**MASTER DEVELOPMENT DRAINAGE PLAN
FOR
MARKSHEFFEL CROSSING**

Job No. 2630.01
PCD File No. SKP-262

MARKSHEFFEL CROSSING
SKETCH PLAN
MASTER DEVELOPMENT DRAINAGE PLAN
PRE-DEVELOPED CONDITIONS

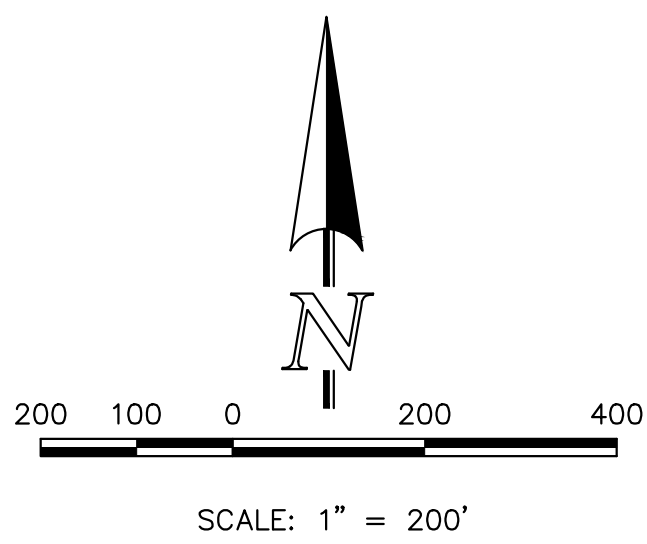
UNRESOLVED:
Where? Did not see any existing storm on plan
